Flight Procedures Cover Page	Task Action: FLIGHT CHECK	Task Type: STAR	Estimated Chart Date: 11/05/2020	APWS Task ID: F09A3357D47847A18891859A7CB15CCA	APWS Project ID: 87B2DE1177444AB98F2BA85E29457D34
Procedure: STAR MADII (RNAV) SIX CHICAGO IL KORD		Enroute: YES	Specialist: Powell, Dan		Agreement Number:
Airport ID: KORD	Airport Name: CHICAGO O'HARE INTL		Airport City: CHICAGO		State: IL
Facility ID:	Facility Type:	Flight Inspection Remark Type: New FC Slot			
<div>Procedure Comments: PBN RNAV STARS-NEW RWY 9C/27C BEING COMMISSIONED.</div> <div>LOA: NO TERMINUS ALTITUDE</div> <div>CONTACT: ROB HAMILTON, AJV-A440 LEAD, 405-954-4608</div> <div>06/17/2020</div> <div>QUALITY 15 CHECKED</div> <div>QUALITY 14 CHECKED</div>

PROCEDURE: STAR MADDII (RNAV) SIX CHICAGO IL KORD		AIRPORT NAME: CHICAGO O'HARE INTL		AIRPORT ID: KORD	SPECIAL CONTROL NO: BG-07-141-20
FAC ID: MADI6		CITY: CHICAGO		ST: IL	ORIG CHART DATE: 11/05/2020
DFL TYPE: PROC/D	THIRD PARTY: <input type="checkbox"/> YES	EST. TIME ON SITE: 1.0	REIMB. NUMBER: AC0683	PTS TASK ID:

PROCEDURE REVIEW BOARD (PRB) Results

7. **Approval Request** – Chicago O'Hare INTL, Chicago, IL (ORD) – MADII SIX (RNAV) STAR, <http://swims.faa.gov/PT

MADII SIX ARRIVAL (RNAV) Transition RoutesCHICAGO O'HARE INTL (ORD)
CHICAGO, ILLINOISD-ATIS
135.4 282.225
CHICAGO APP CON
119.0 292.125

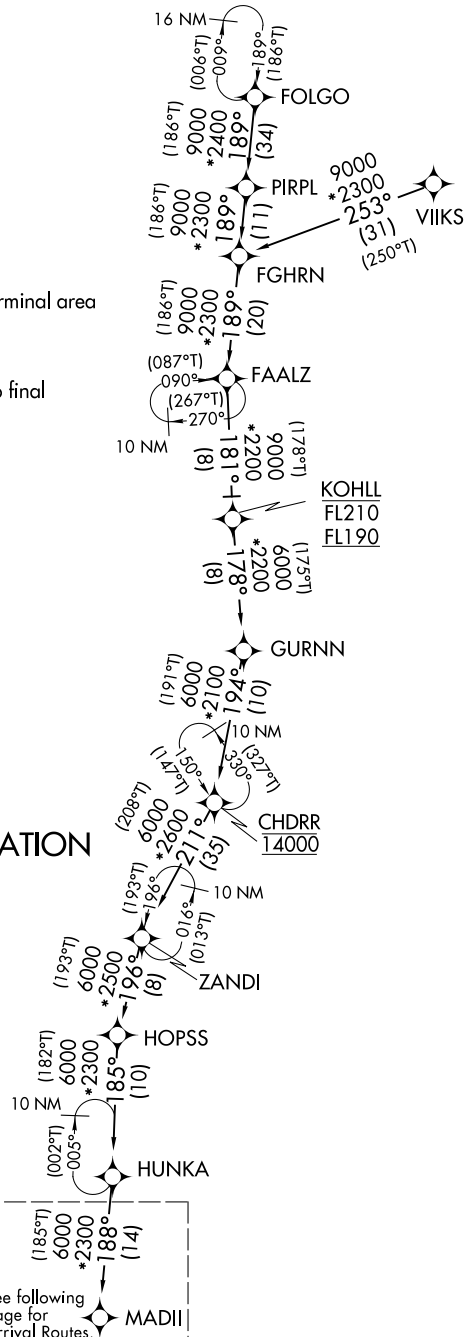
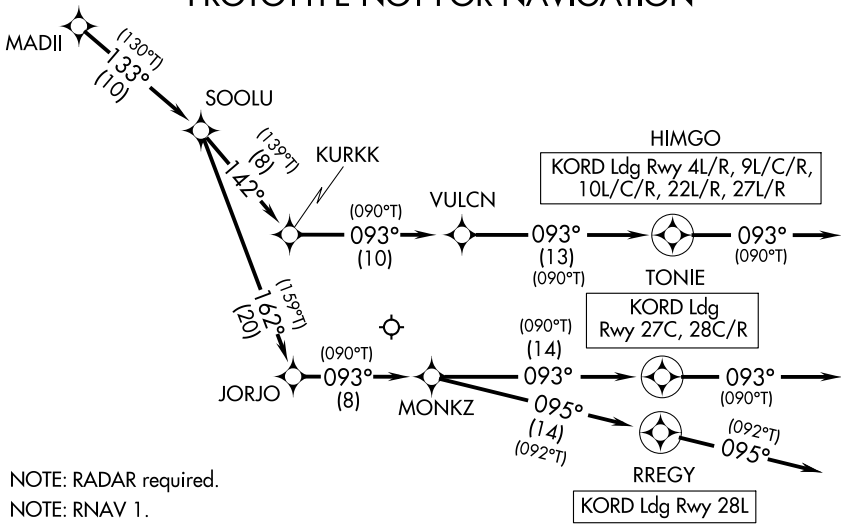
FLIGHT INSPECTOR REMARKS: NOTE: FIPC cover sheet -- change MADDII SIX to MADI SIX. Typo.		
--	--	--

FLIGHT INSPECTOR REMARKS: NOTE: FIPC cover sheet -- change MADDII SIX to MADII SIX. Typo.		
---	--	--

- Approval request is only asking for approval to publish the procedure without a mandatory altitude at RREGY, however, this approval also needs to address HIMGO and TONIE.
 - No record found that would indicate existence of a previously approved approval request for HIMGO and TONIE.
- TYPO Change MADDI to MADII

SEE UPDATED COPY
